CITY OF DULUTH

File Number	PL 18-122	Contact	Jenn Reed Moses	
Type	MU-W Planning Review	Planning Commission Date	November 13, 2018	
Deadline for Action	Application Date	September 20, 2018	60 Days	November 19, 2018
	Date Extension Letter Mailed	October 1, 2018	120 Days	January 18, 2019
Location of Subject	1033 Minnesota Avenue			
Applicant	Park Point Marina Inn and Suites LLC	Contact	Terry Anderson	
Agent	N/A	Contact	N/A	
Legal Description	010-4390-02090, 010-4400-00780			
Site Visit Date	October 2, 2018	Sign Notice Date	September 25, 2018	
Neighbor Letter Date	October 1, 2018	Number of Letters Sent	23

Proposal

The applicant is proposing a 3 story, 6,100 square foot, 15 room addition to the southeast side of the existing hotel. Staff has revised the report and proposed conditions since the October 9, 2018 Planning Commission meeting where the Applicant's request was tabled.

1 PARKING 30% SHADING AREAS
L-3 SCALE: 1"=30'

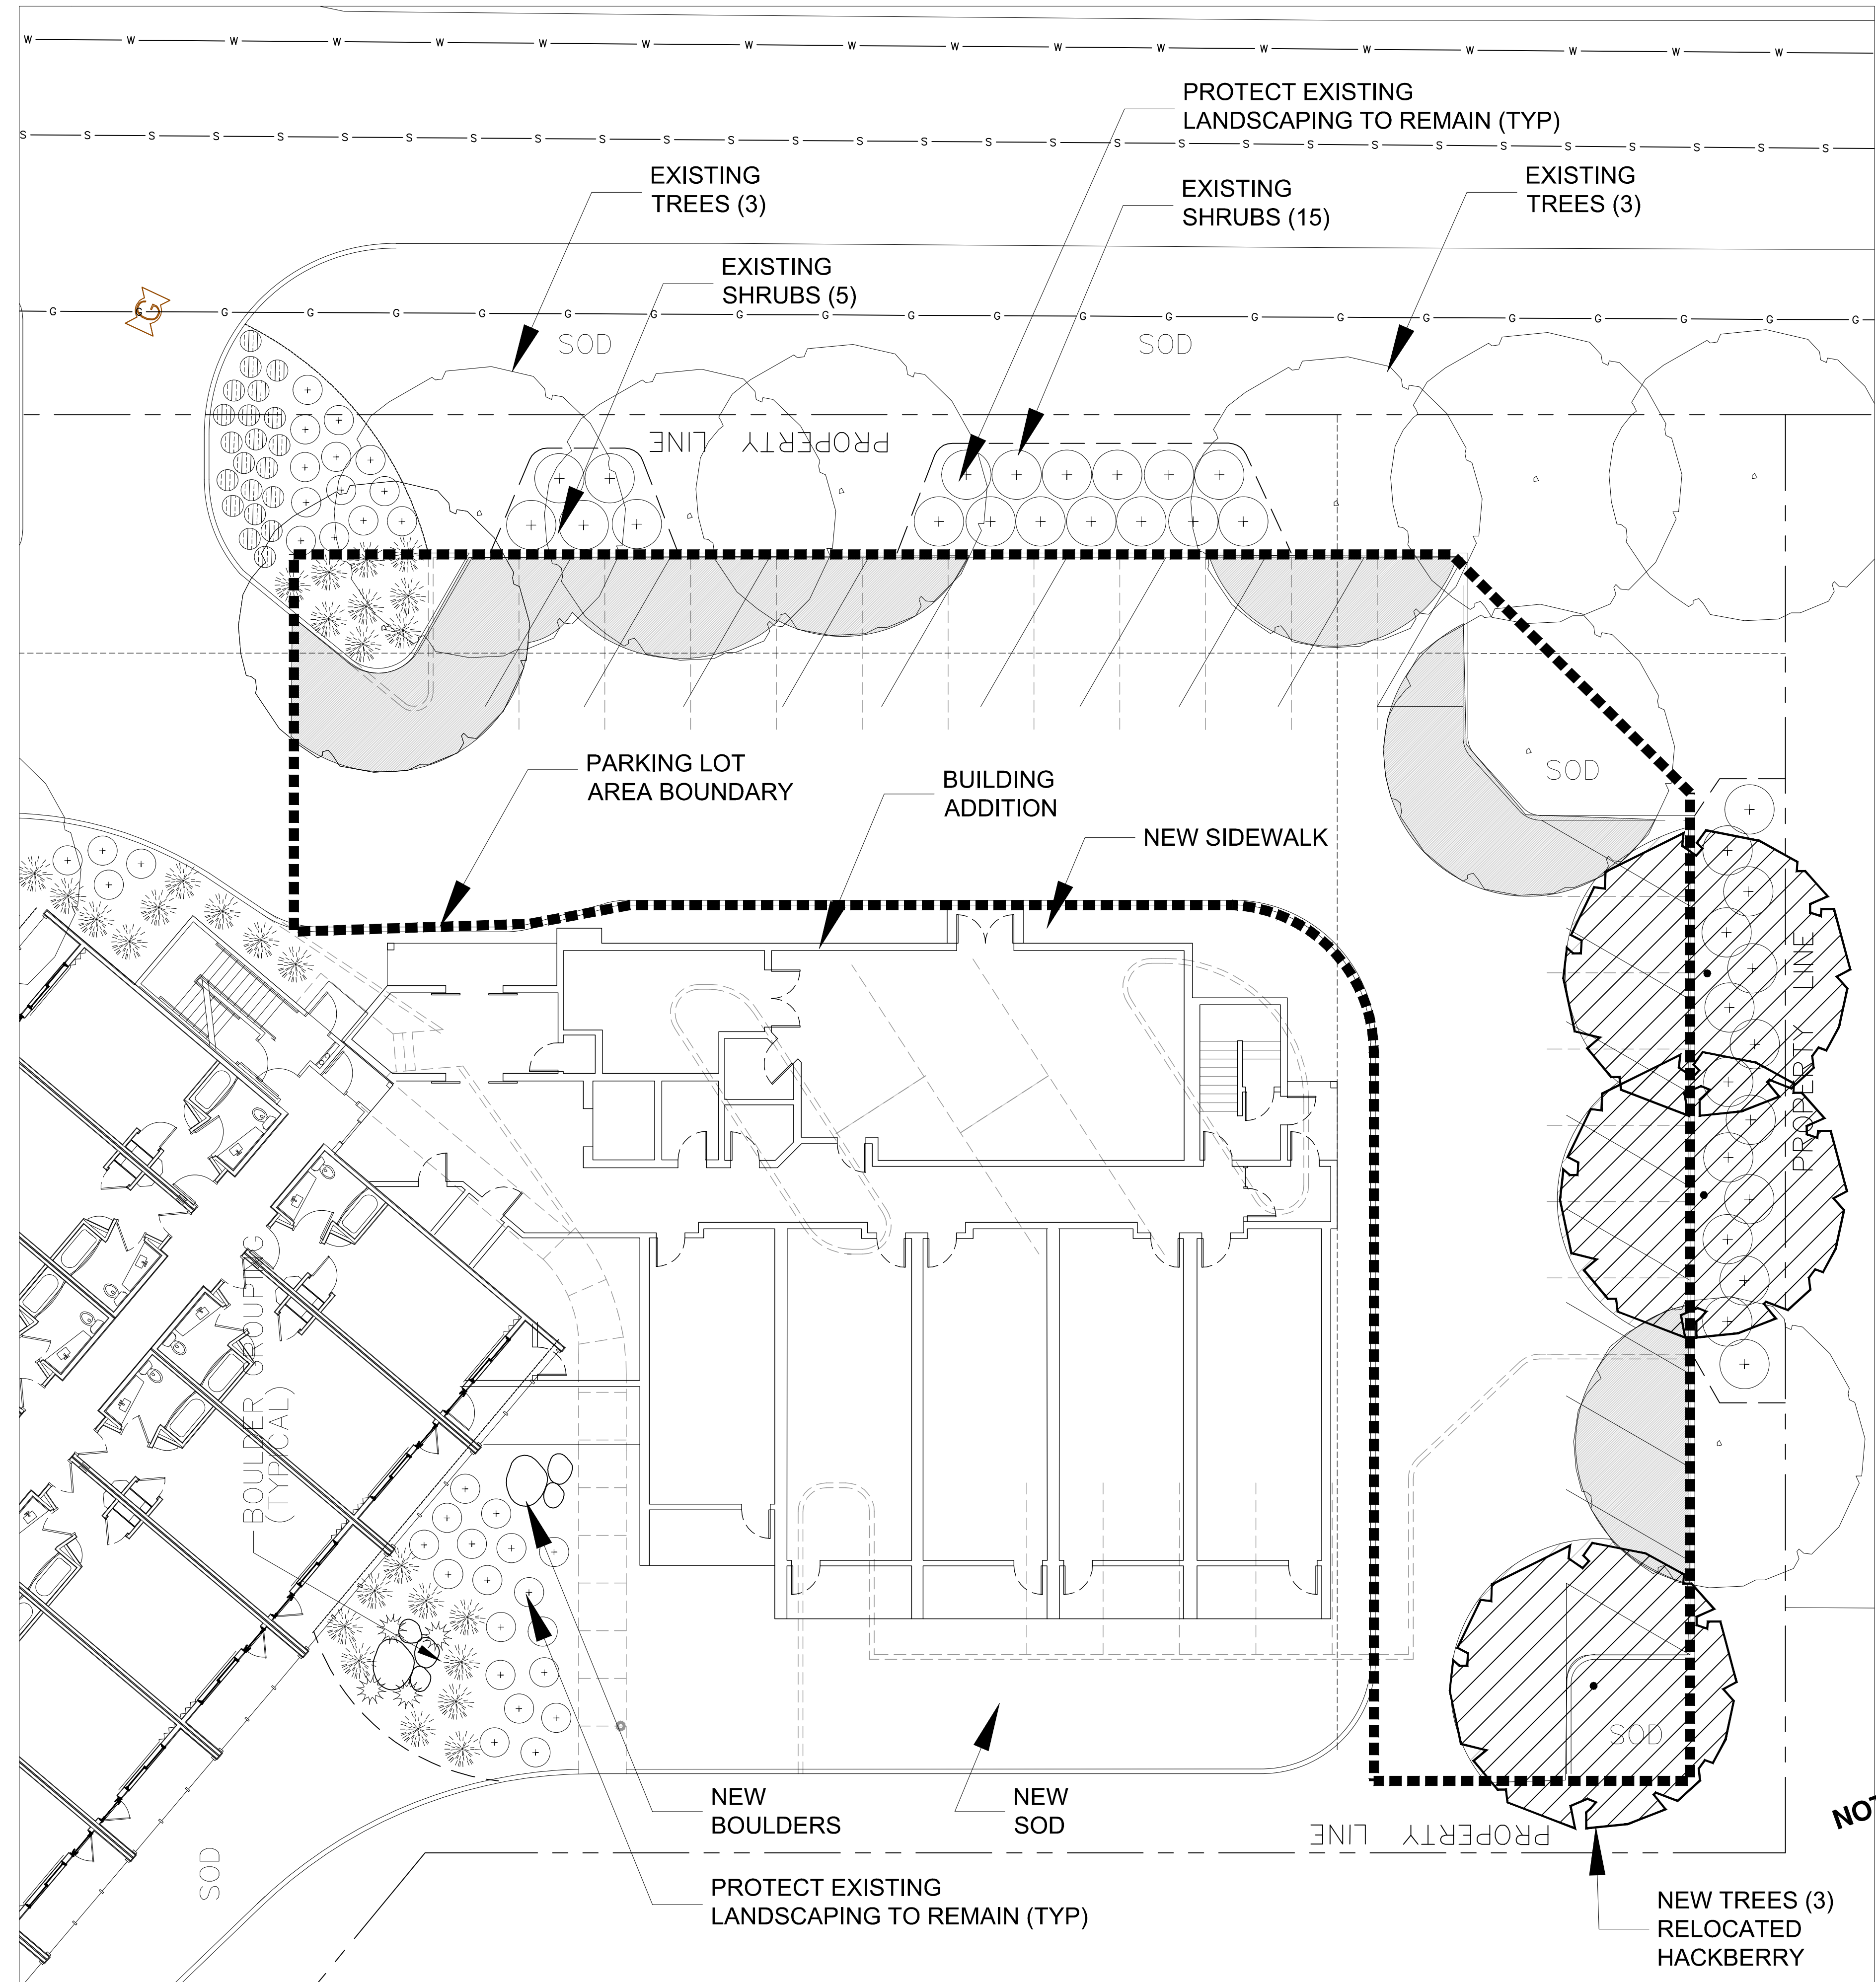
- 7) 50-25 (Landscaping and Tree Preservation) - Landscape Plans indicate that the proposed expansion project will provide the required tree canopy coverage and frontage landscaping requirements.

PROPOSED ADDITION - HARBOR ELEVATION

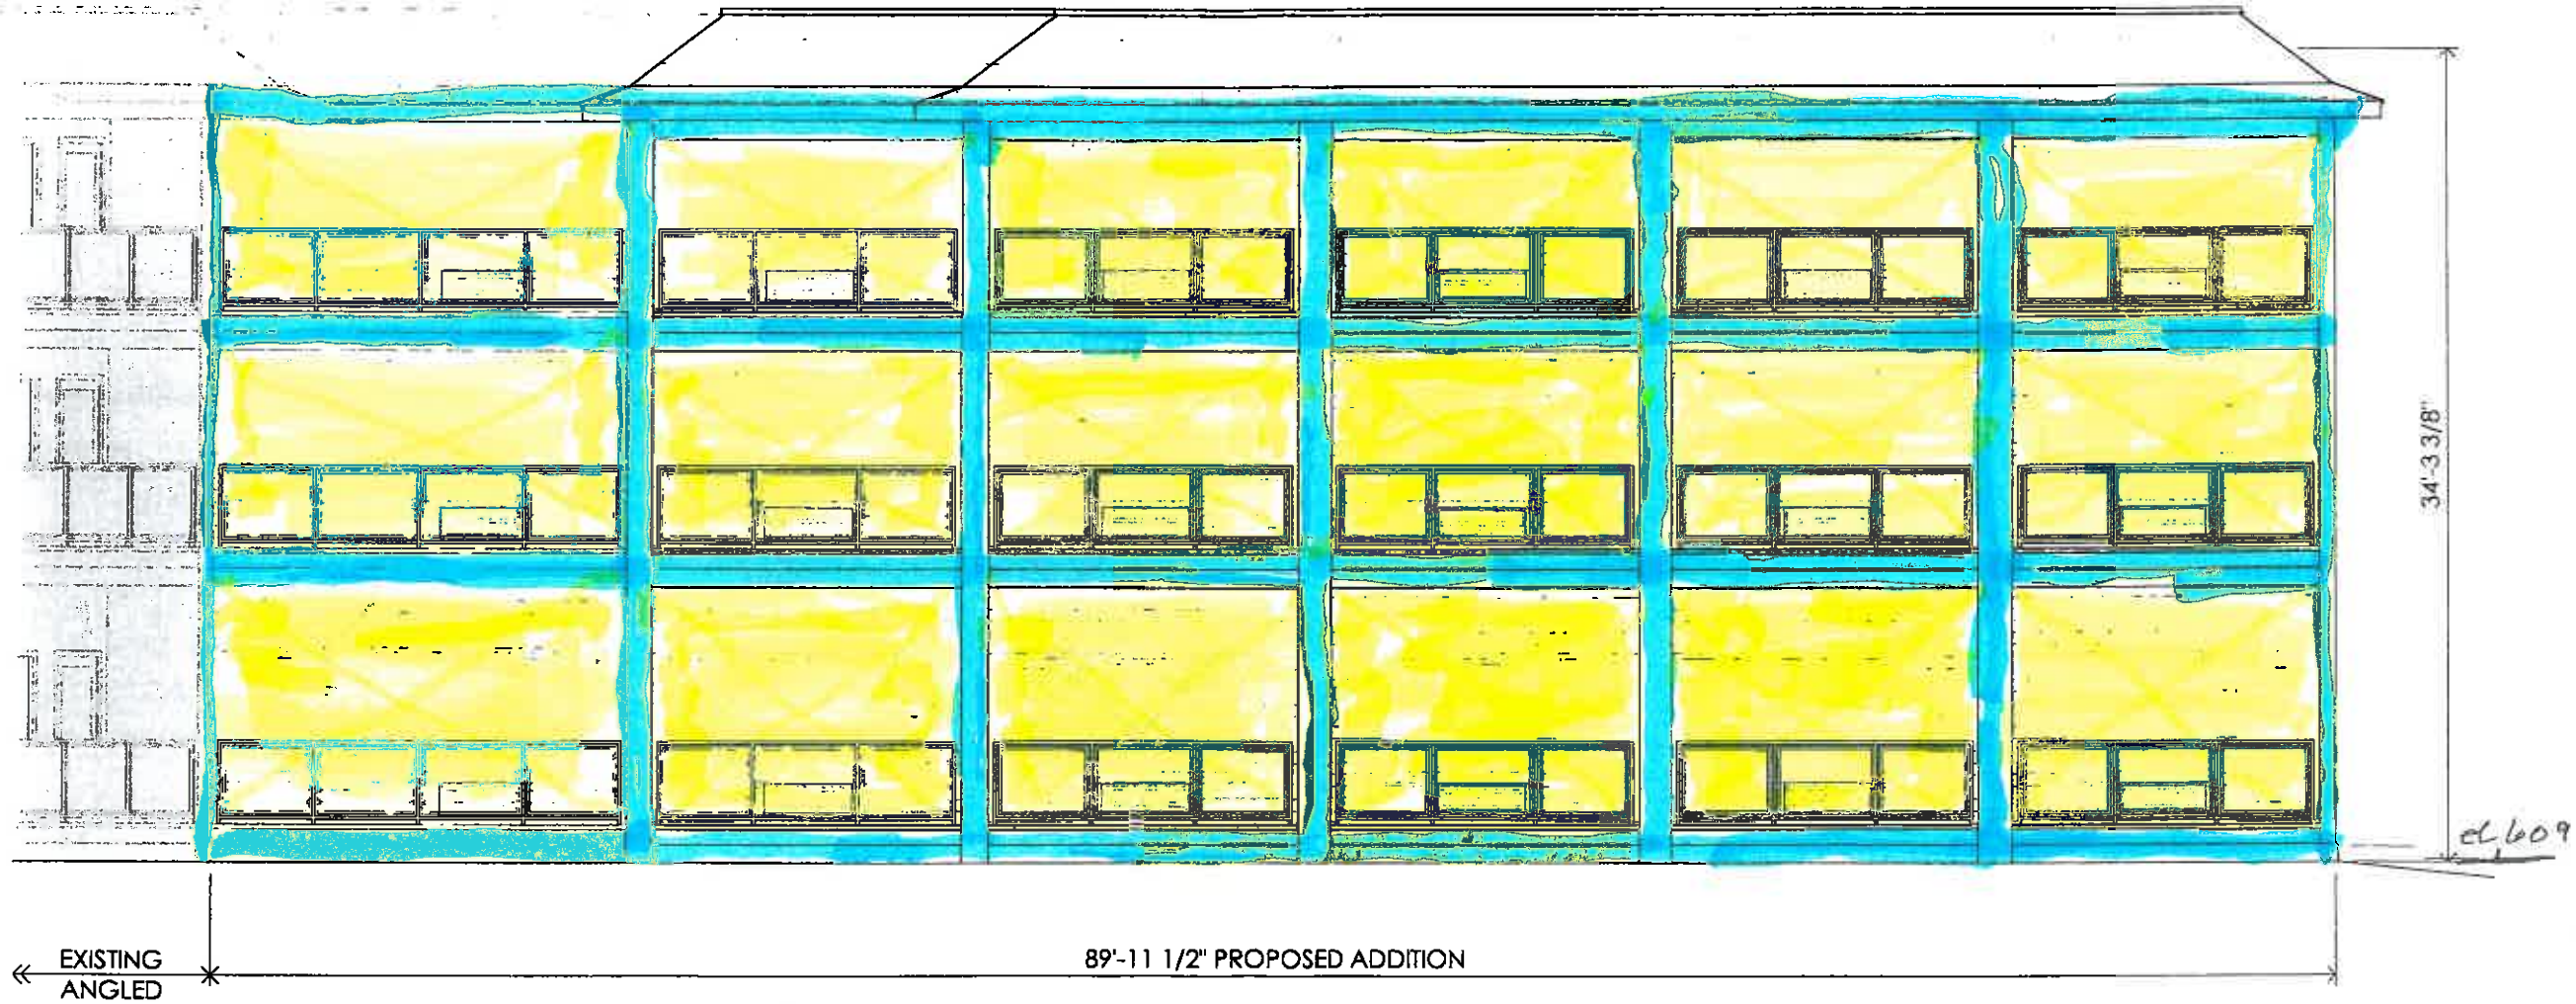
- 3) 50-15.6.E (Development Standards) – #2 The proposed expansion will meet the required minimum 50 foot setback from adjacent structures. #4 Applicant states the project will meet the minimum 40% transparency requirement along the waterfront. #5 The proposed expansion will add rooms and take away existing off-street parking spaces; see item 5 below.

3. Prior to issuance of a building permit, Applicant shall submit professionally drawn elevations signed by a Licensed Architect that include measurements demonstrating that the façade facing the water meets the 40% transparency requirement of the UDC.

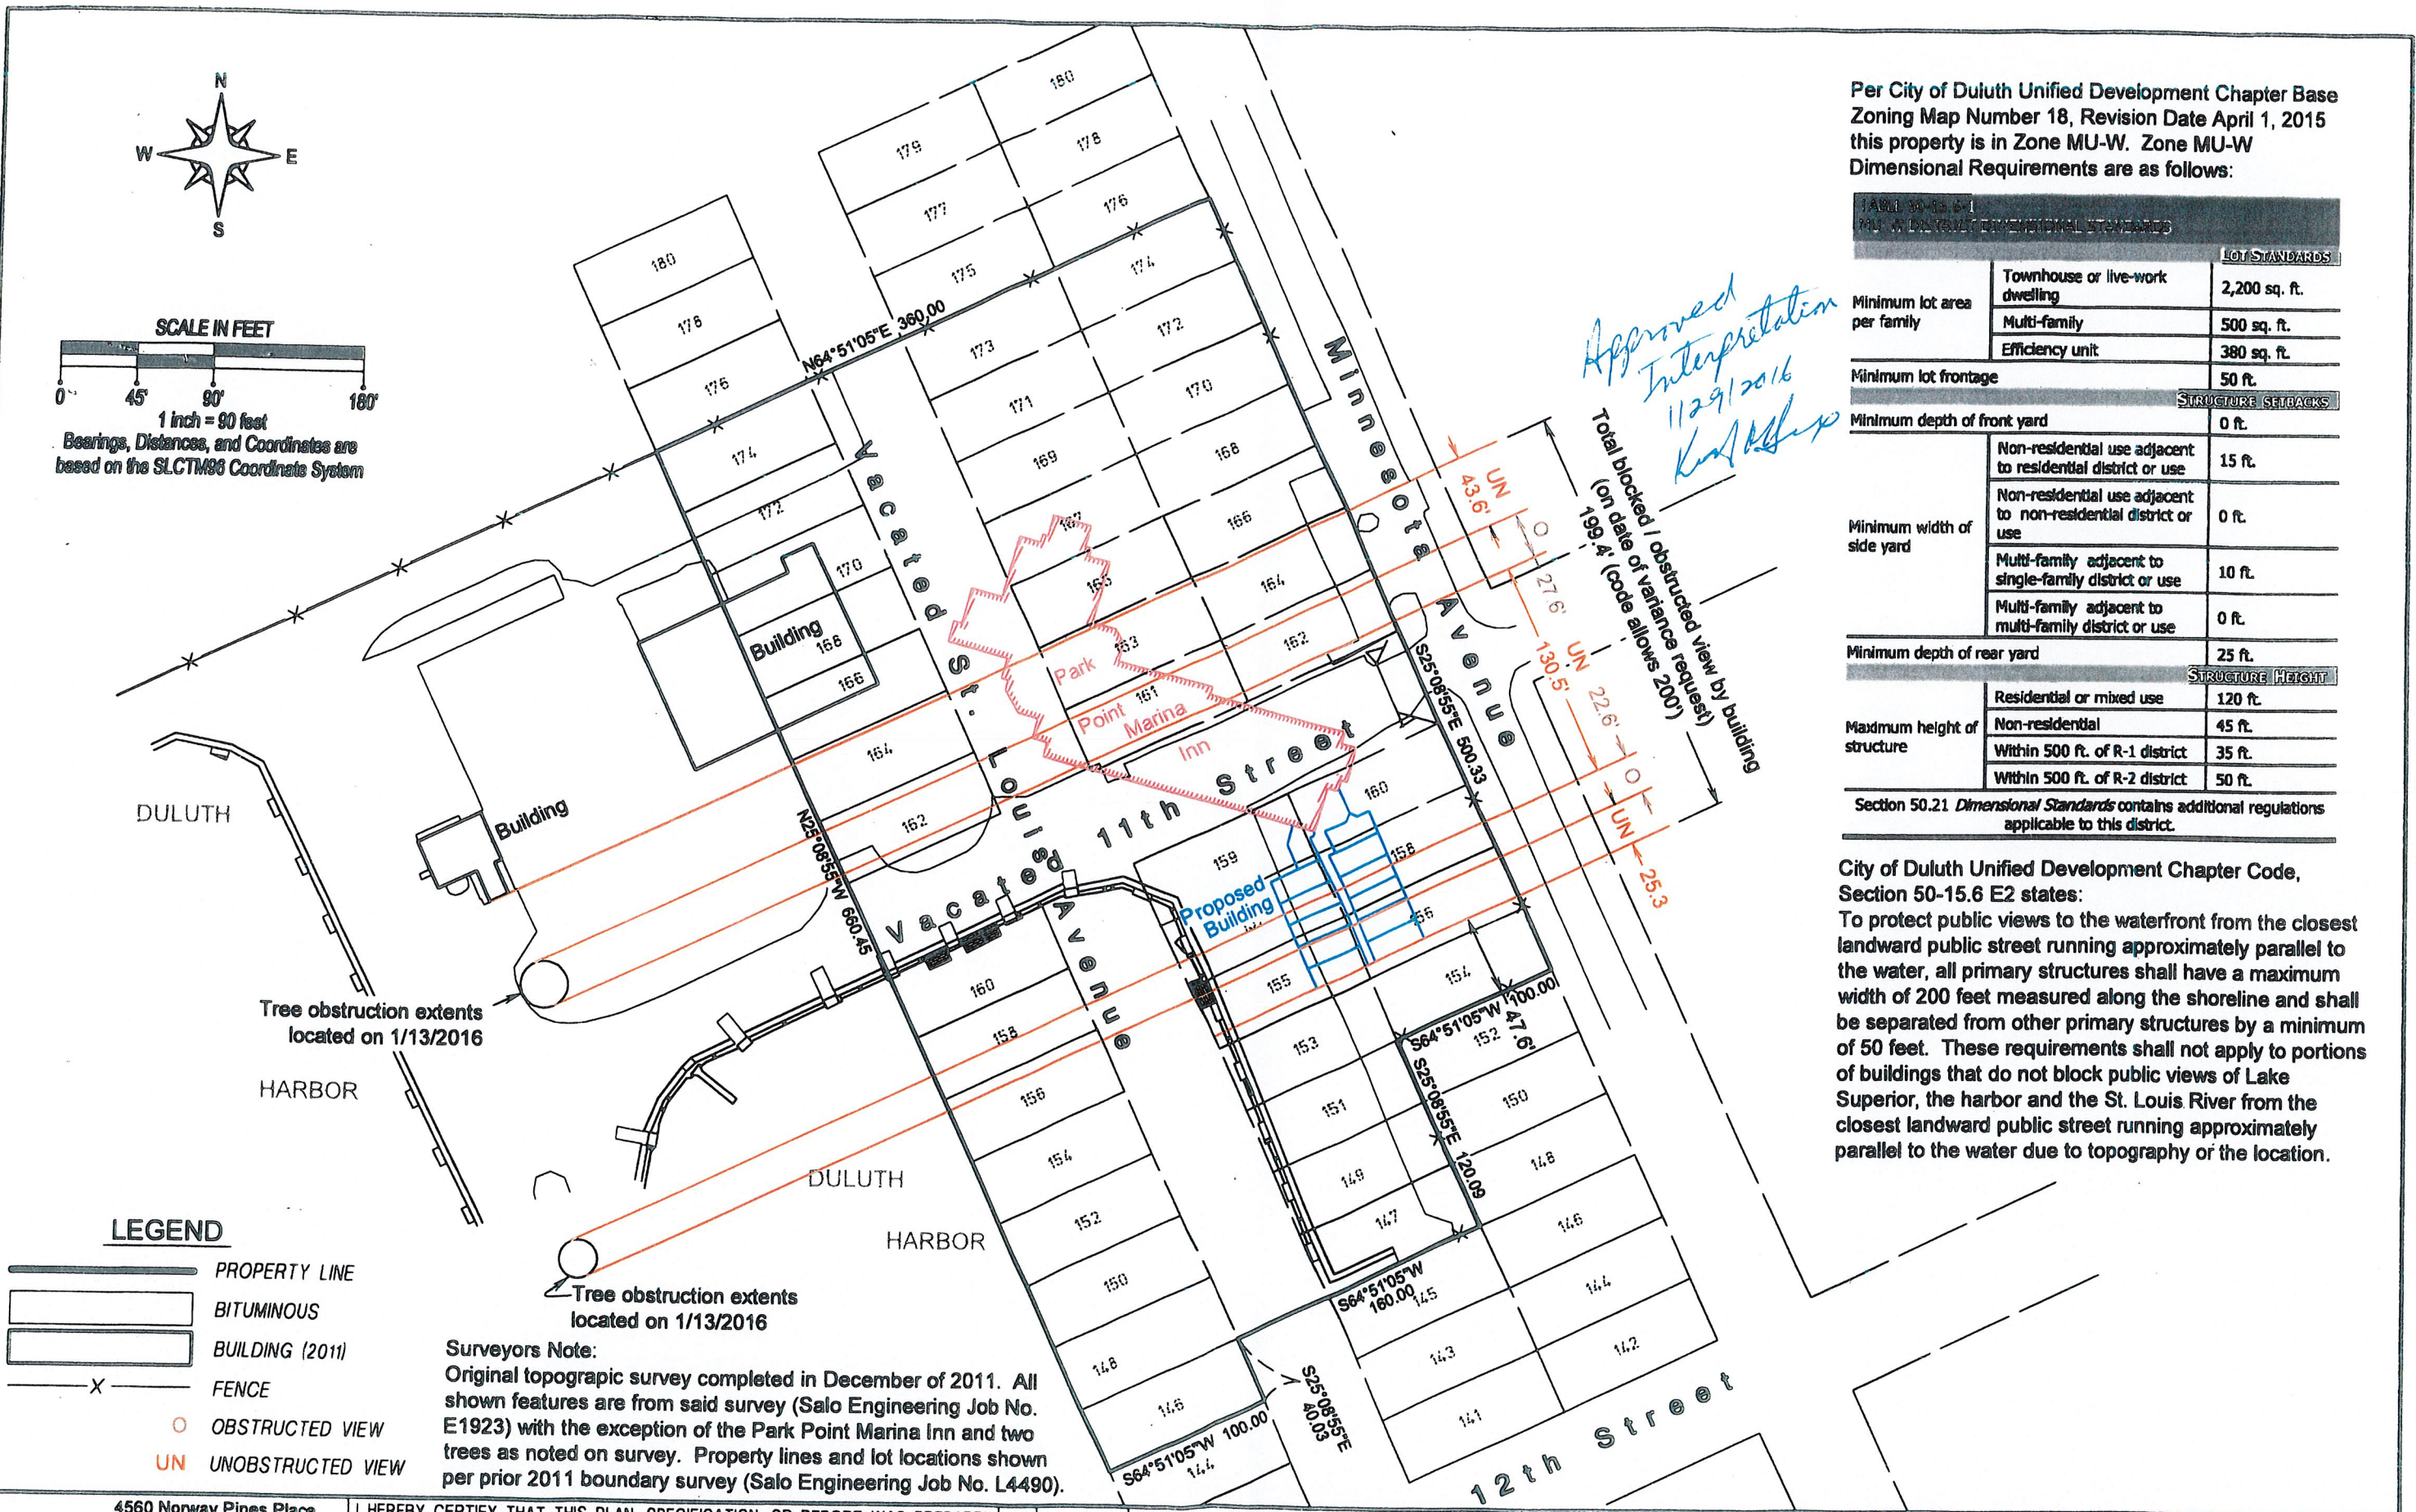
In 2015, applicant sought to define maximum width for the structure along Minnesota Avenue. On August 10, 2015, City Council affirmed Planning Commission's decision to deny an appeal of a Land Use Supervisor's decision related to the interpretation of the MU-W zone district and the 200-foot rule (PL 15-030). On December 18, 2015, Planning Commission denied a variance (PL 15-165) from the 200 foot MU-W limit. Applicant submitted an appeal to the City Council, which was later withdrawn. On January 29, 2016, the Land Use Supervisor issued an interpretation related to this hotel and the limits of a possible expansion within the confines of the 200-foot standard. The applicant asserted that exceptions from the 200-foot limit include any areas previously blocked from view due to existing buildings or trees, based on a dictionary definition of "topography." The Land Use Supervisor agreed with this definition and signed the site plan based interpretation allowing for areas previously occupied by trees and the existing marina building to be excluded from the 200-foot maximum. The site plan showing these measurements, as approved by the Land Use Supervisor, is attached to this staff report.
